Access Compliance Report

Public Rights-of-Way

(Curb Ramps)

Intersection ID: 18204	Main Street: IDLEWILD_RD	Cross Street: OAK_DR	Location: W
ADA ID: 9369683E59CE	Ramp Type: BlendTrans1	Initial Pass/Fail: Pass	Overall Compliance: No
Severity Score: 0.25			
Codes/Mitigation Info/Possible Solution		Field Measurements/Component Compliance

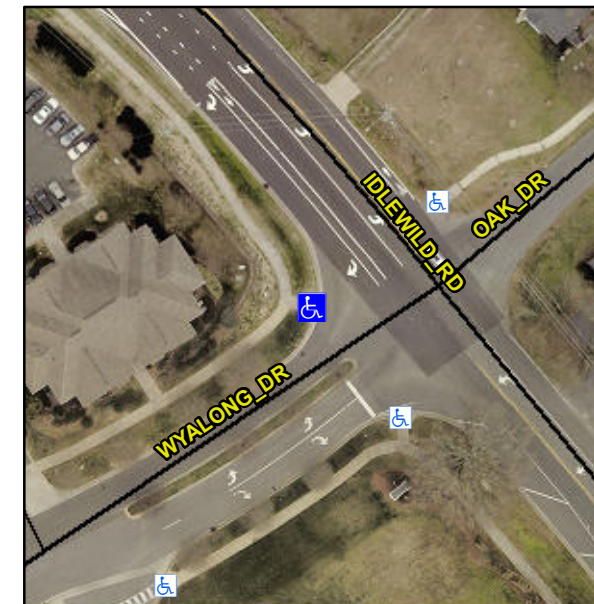
Not Found, R304.5.3

Compliance	Description	Data	Compliance	Description	Data
N/A	Ramp Length (in)	72.0	Yes	BlendTrans Slope (%)	4.8
Yes	Ramp Width (in)	48.0	No	BlendTrans XSlope (%)	2.2
N/A	Flare Type LT	Sloped	N/A	Flare Type RT	Sloped
N/A	Flare Slope LT (%)	8.4	N/A	Flare Slope RT (%)	3.8
N/A	Flare Traversable LT?	No	N/A	Flare Traversable RT?	No
Yes	Landing Length (in)	81.0	Yes	DWS Provided?	Yes
Yes	Landing Width (in)	48.0	Yes	DWS Contrast?	Yes
Yes	Landing Slope (%)	0.4	Yes	DWS Length (in)	24.0
Yes	Landing X Slope (%)	0.7	Yes	DWS Full Width?	Yes
N/A	Landing Curb? (Y/N)	No	Yes	DWS Offset (in)	0.0
N/A	Shared Landing?	No			
Yes	Gutter Ponding?	No	Yes	Gutter Slope (%)	2.9
Yes	Gutter Lip Ht (in)	0.0	Yes	Gutter X Slope (%)	1.4
N/A	Painted X Walk1?	No	N/A	Painted X Walk2?	No
	X Walk 1 Direction	To SE		X Walk 2 Direction	To NE
	X Walk 1 Width (in)	N/A		X Walk 2 Width (in)	N/A
	X Walk 1 Slope (%)	2.2		X Walk 2 Slope (%)	2.2
	X Walk 1 X Slope (%)	0.2		X Walk 2 X Slope (%)	3.1

N/A	Ramp inside XWalk1?	N/A	N/A	Ramp inside XWalk2?	N/A
	Road Slope (%)	2.1		Clear Space?	Yes
	Road X Slope (%)	2.8	N/A	Clear Space to XWalk (in)	N/A
Yes	Any Obstructions?	No	Yes	Storm Grate/Utility Hazard?	No
	Obstruction Type			Storm Grate/Utility Type	
		N/A			N/A
			Yes	Surface Condition? (G/P)	Good
			No	Curb Slope (%)	13.5

Remove & Replace Curb Ramp With Two New Directional Ramps or Equivalent.
